DA (AMENDED)

67 PP
67 Pacific Parade DEE WHY NSW 2099

DRAWING TITLE
SITE CONTEXT PLANS

1 SECTION AA
1:200

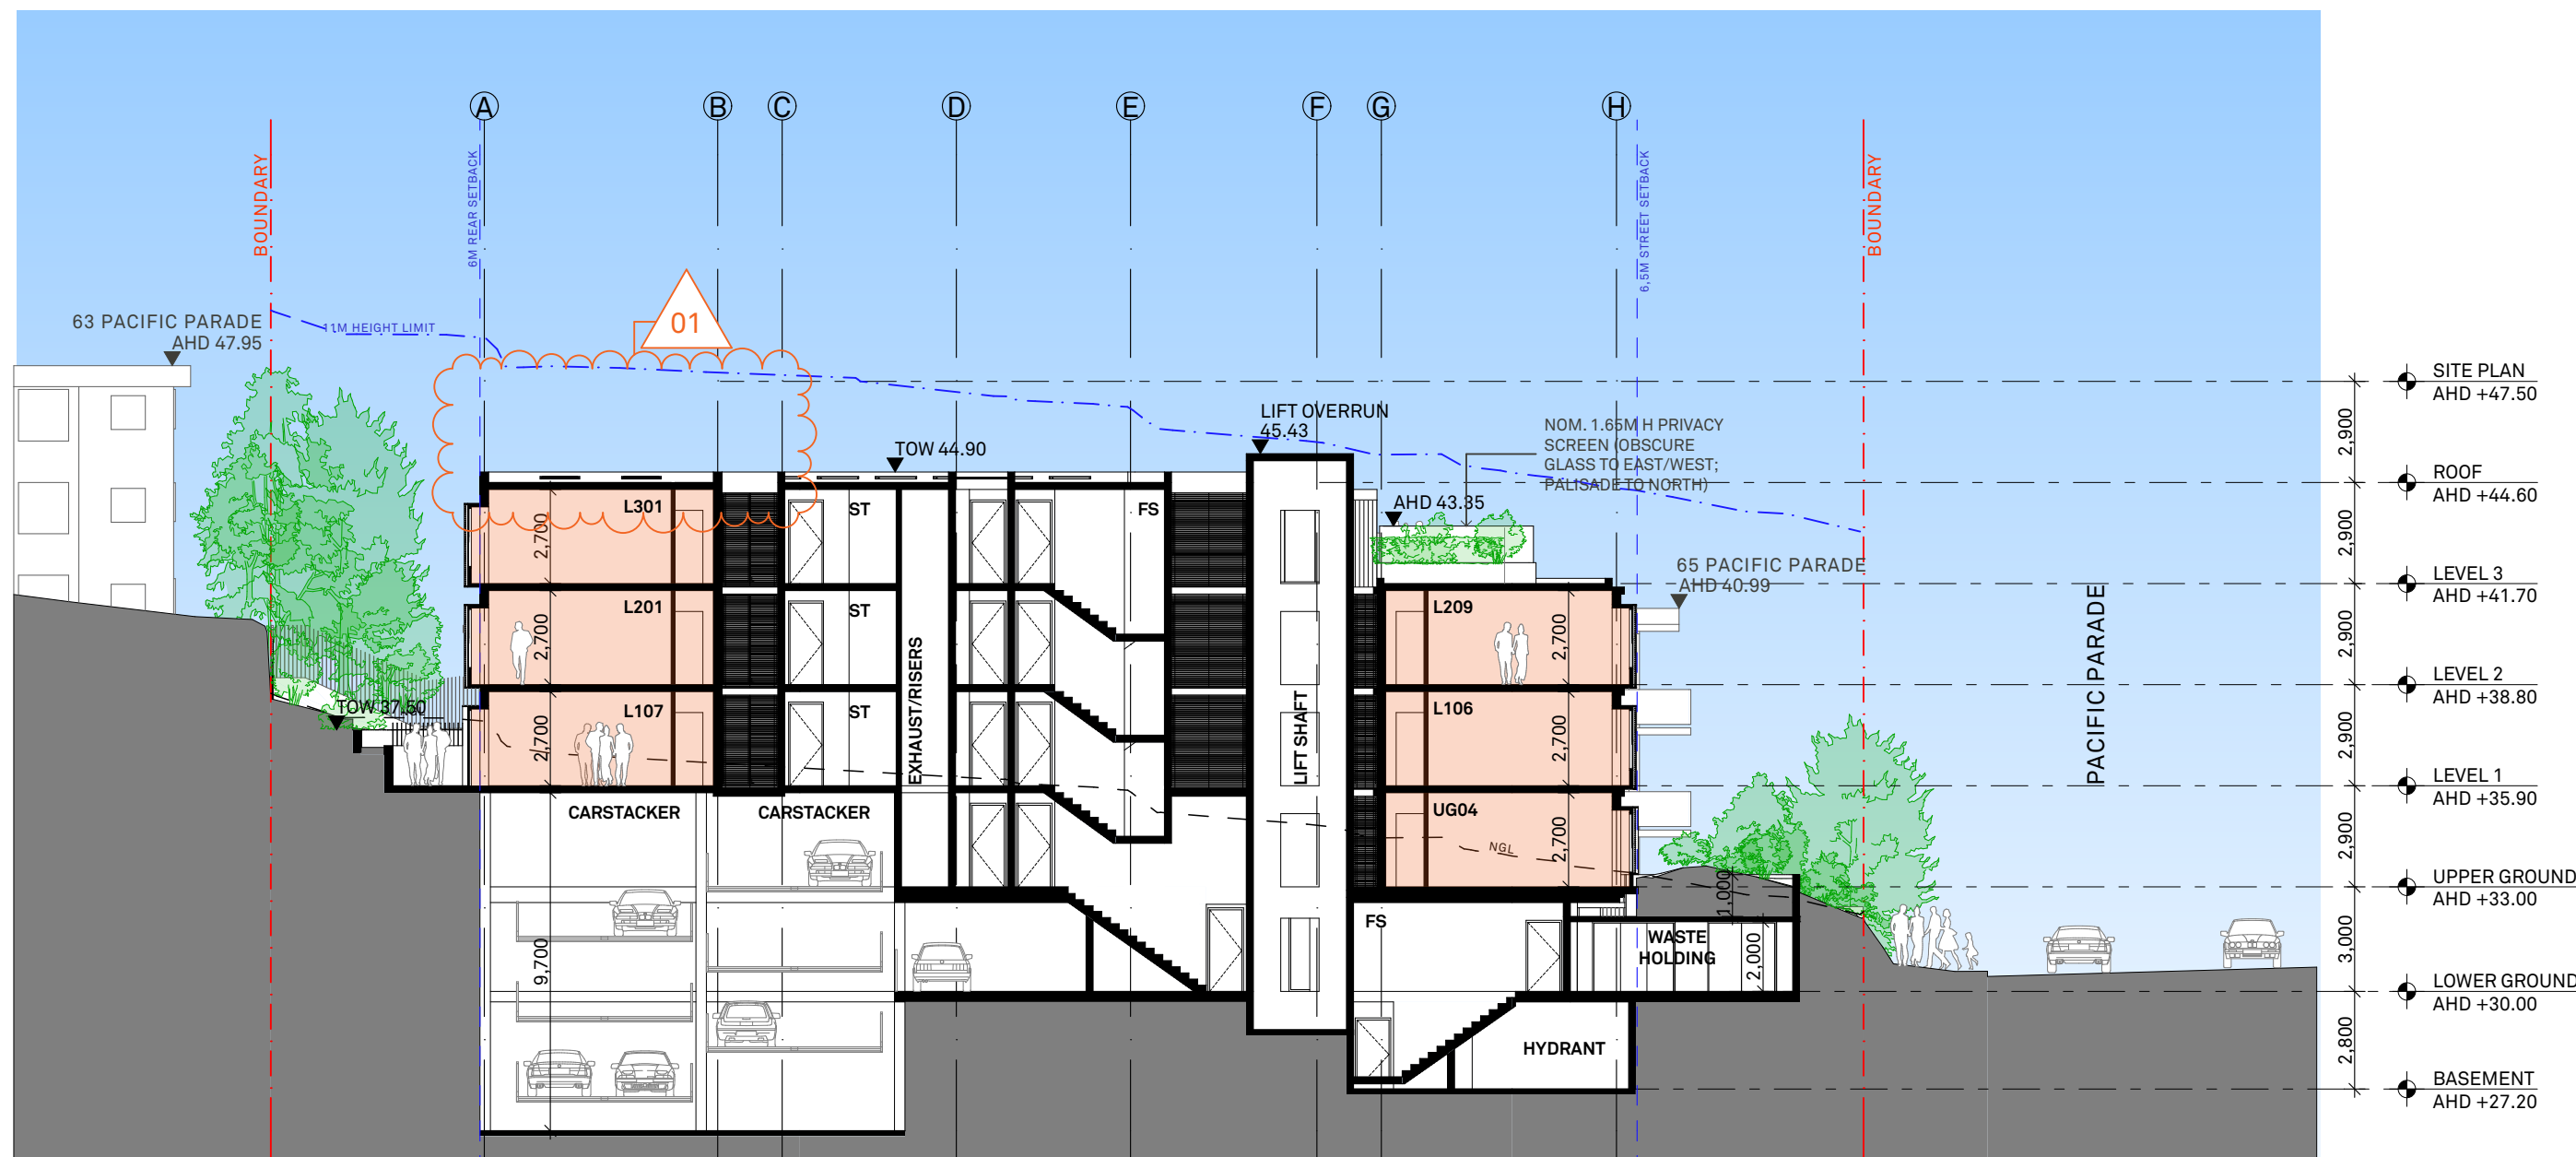
- 01 DELETE LOFT BEDROOMS; REPLACE TYPE E ROOM WITH TYPE B
- 02 REMOVE BASEMENT FLOOR, LOWER LEVEL COMMON ROOM (LWR GRD); INSTALL CAR STACKERS
- 03 REPLACE GARBAGE ROOM WITH BIN HOLDING AREA; INCREASE SOIL DEPTH ABOVE WASTE ROOMS.
- 04 RE-LABEL ROOMS FROM UG05 TO UG04
- 05 REDUCE AREA OF COMMUNAL OPEN SPACE; PRIVACY SCREEN TO COMMUNAL OPEN SPACE

DRAWING TITLE
SECTIONS -
SECTIONS CC/DD

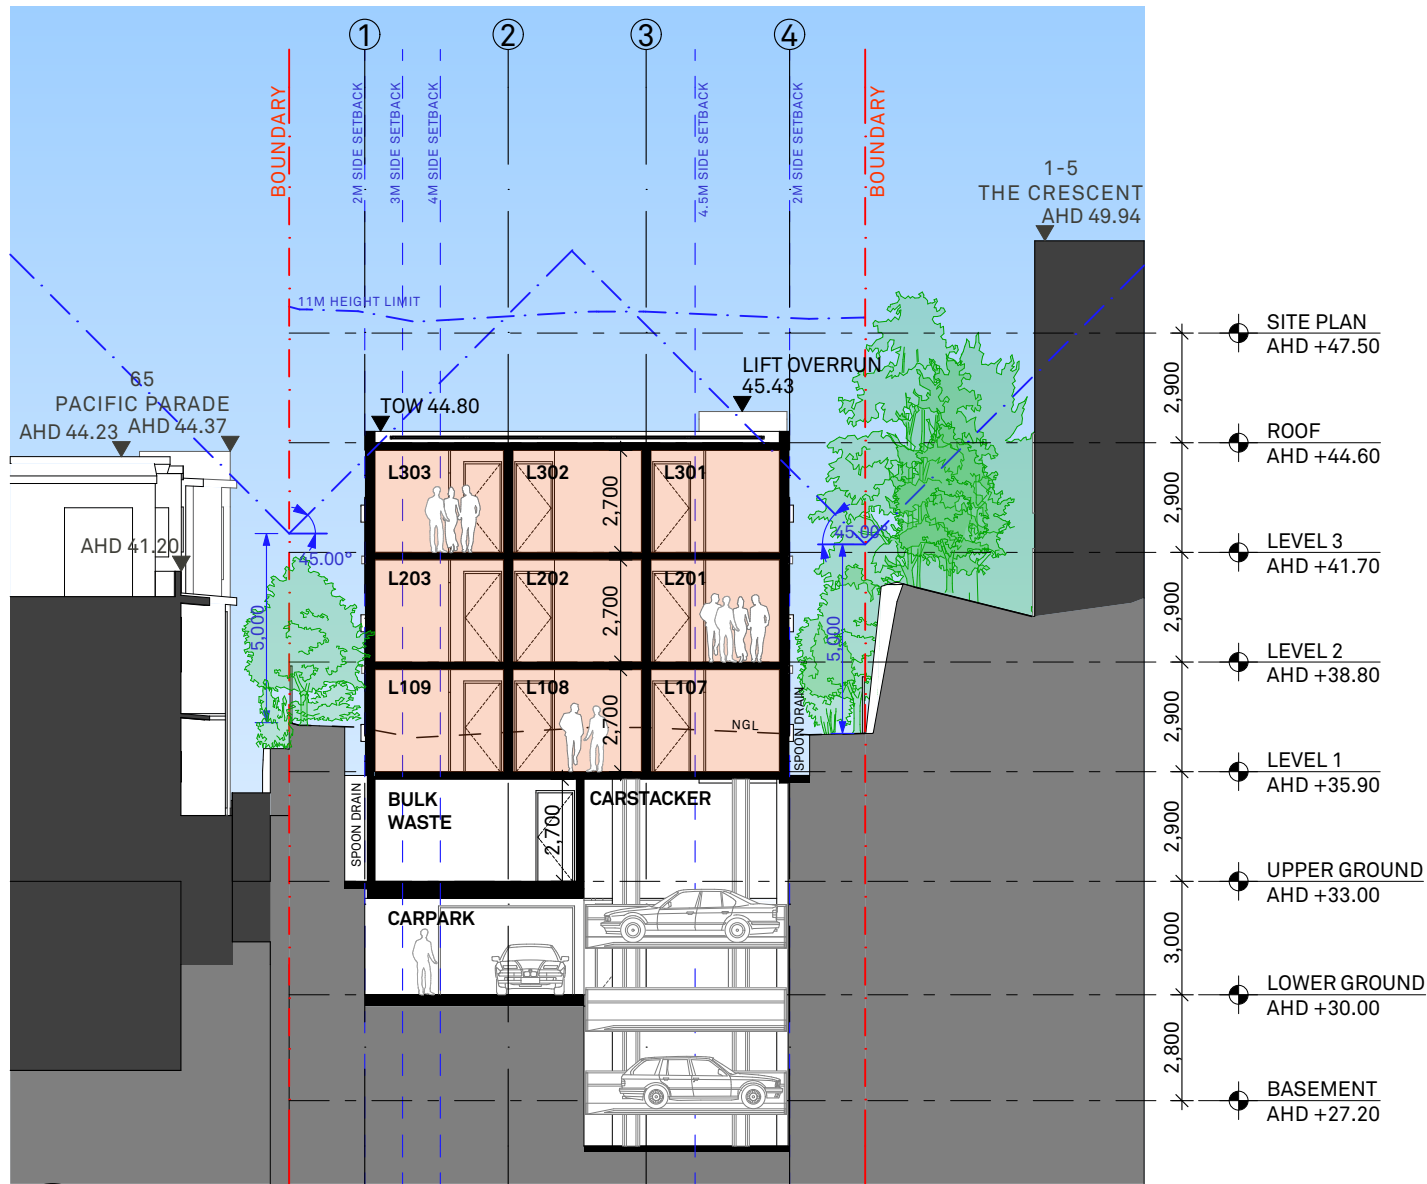
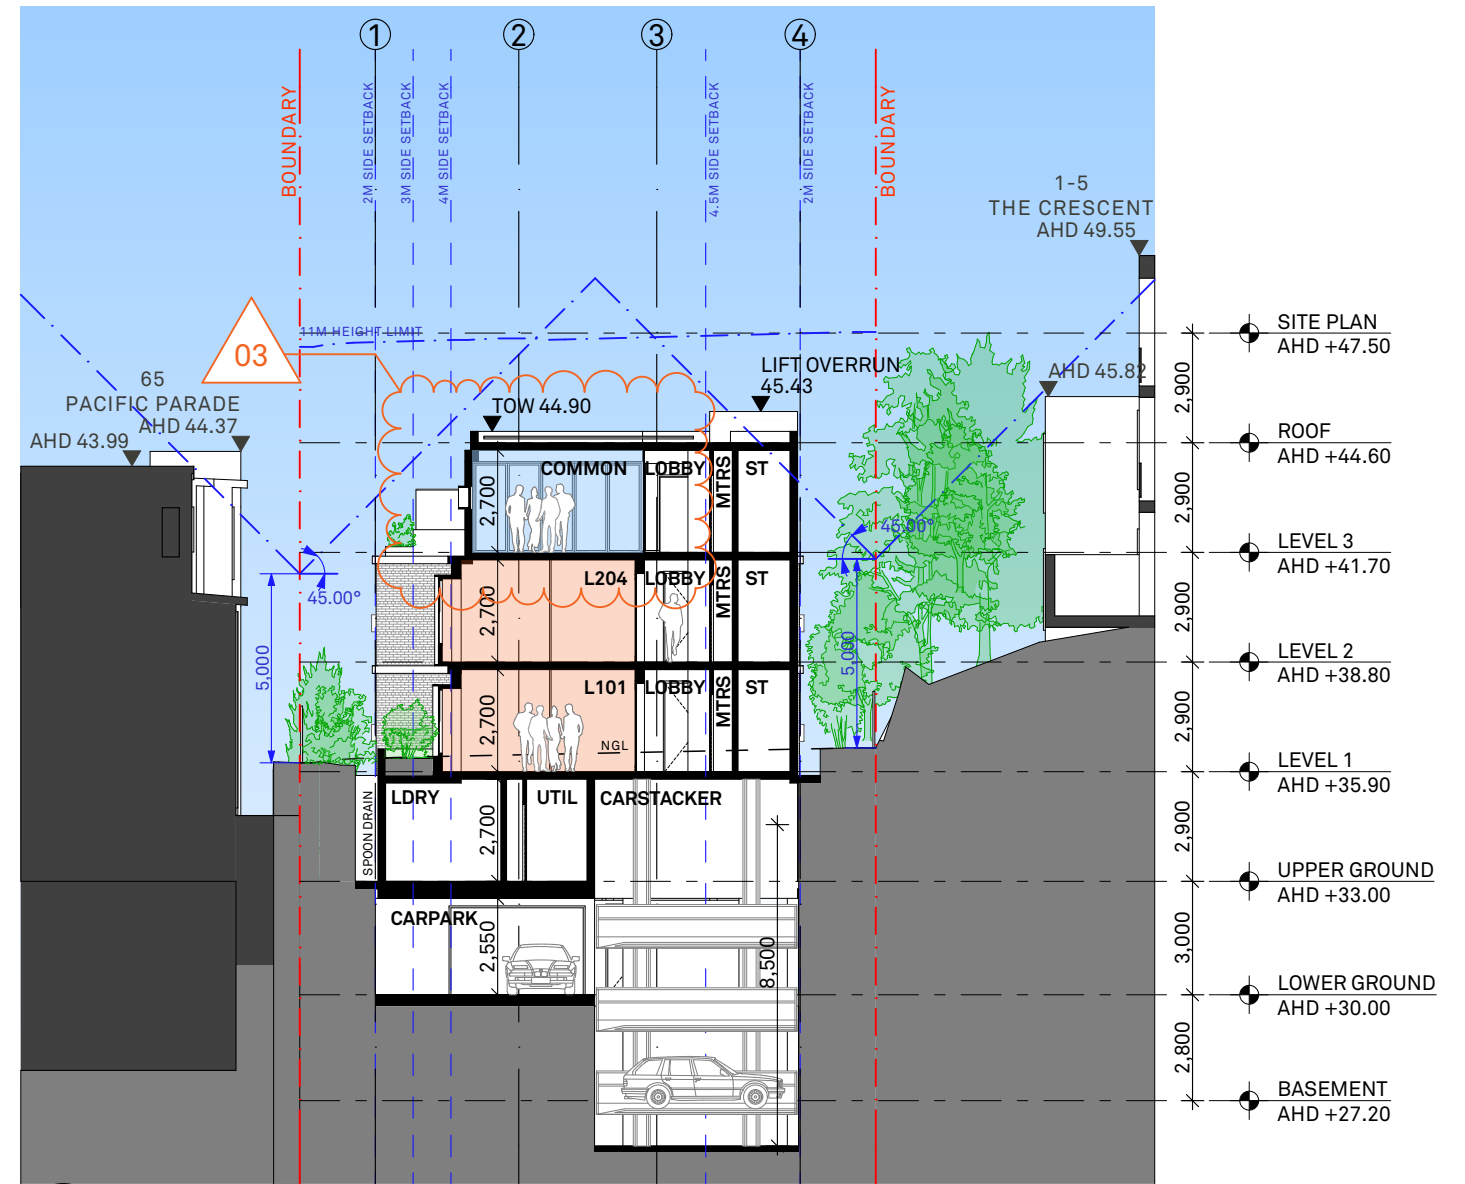
- 01 DELETE LOFT BEDROOMS; REPLACE TYPE E ROOM WITH TYPE B
- 02 REMOVE BASEMENT FLOOR, LOWER LEVEL COMMON ROOM (LWR GRD); INSTALL CAR STACKERS
- 03 INCREASE SIZE OF COMMON ROOM AND COMMUNAL OPEN SPACE

DRAWING TITLE
SECTIONS -
SECTIONS EE/FF

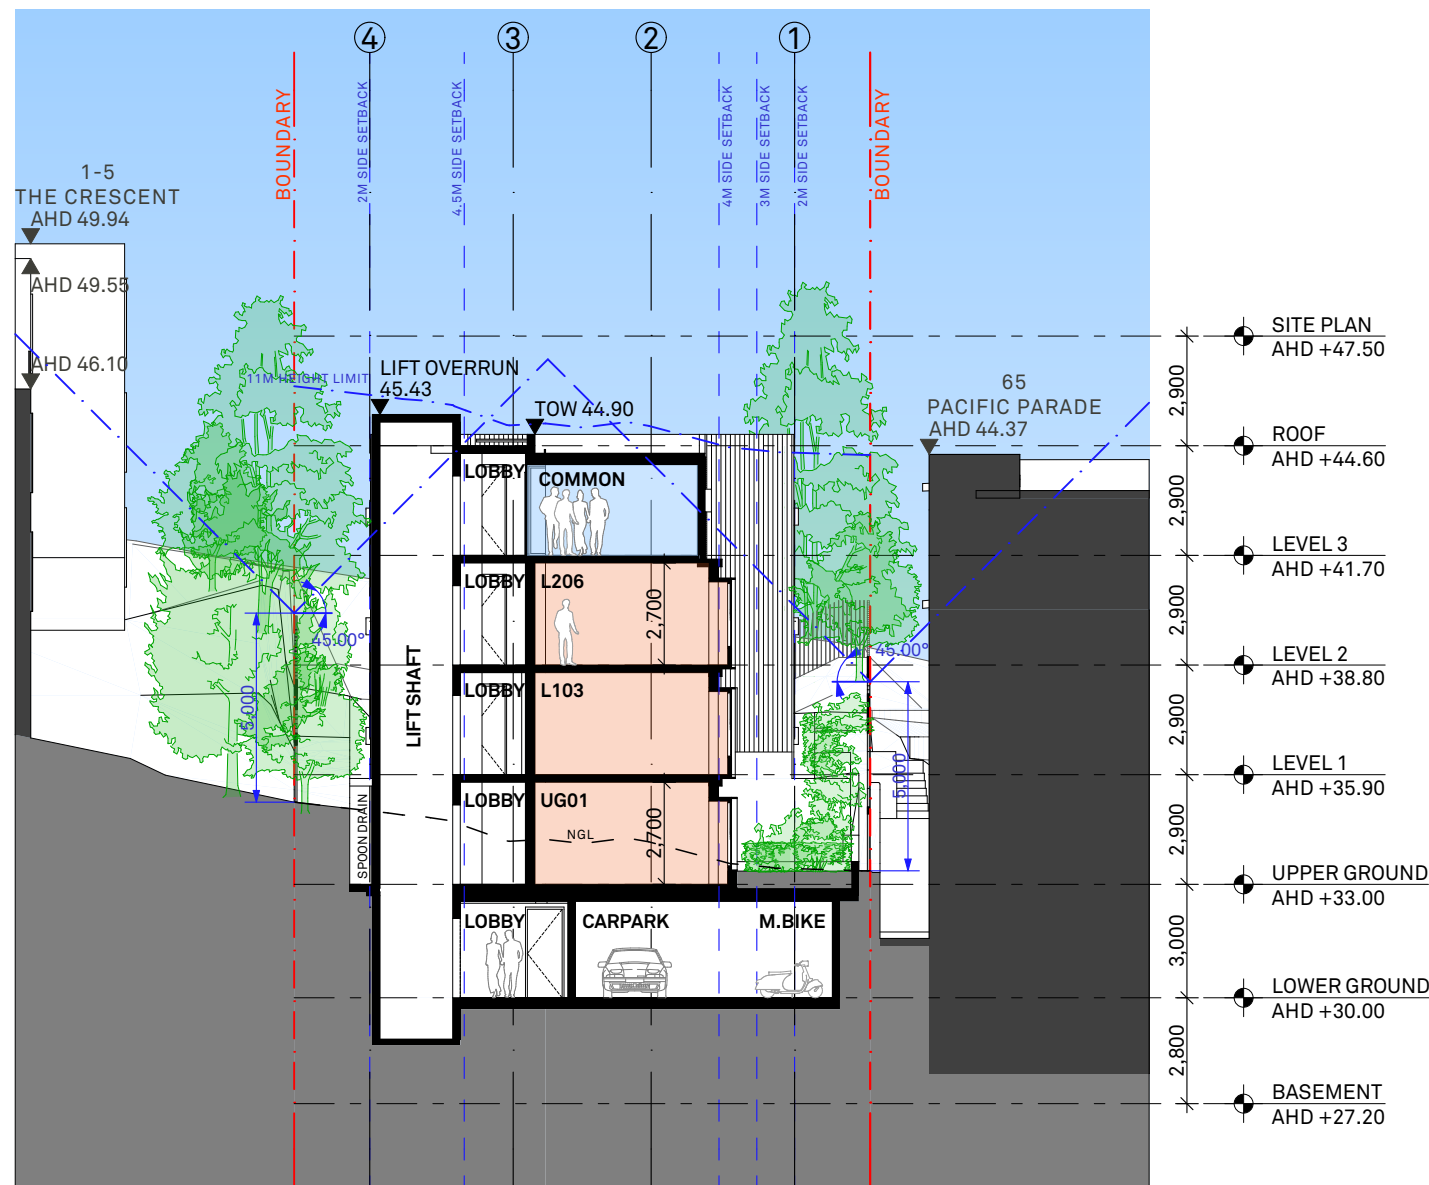
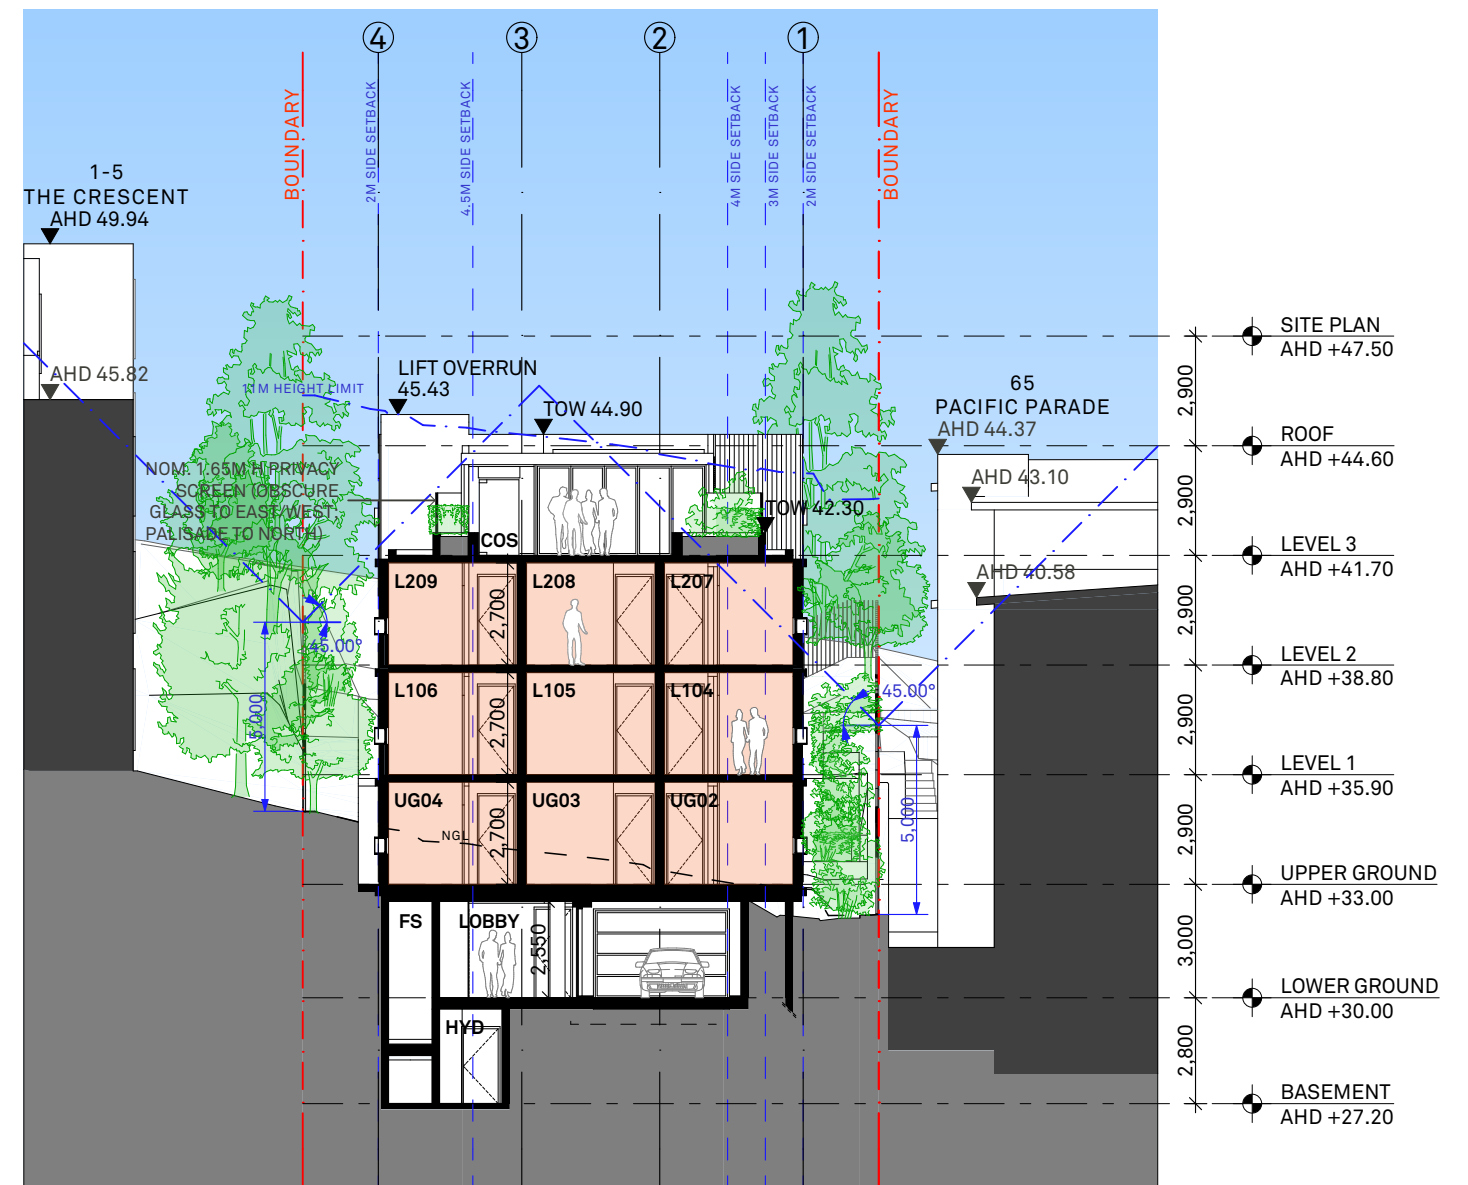
- 01 DELETE LOFT BEDROOMS; REPLACE TYPE E ROOM WITH TYPE B. INCREASE SIZE OF COMMON ROOM AND COMMUNAL OPEN SPACE
- 02 REMOVE BASEMENT FLOOR, LOWER LEVEL COMMON ROOM (LWR GRD); INSTALL CAR STACKERS
- 03 PRIVACY SCREEN TO COMMUNAL OPEN SPACE
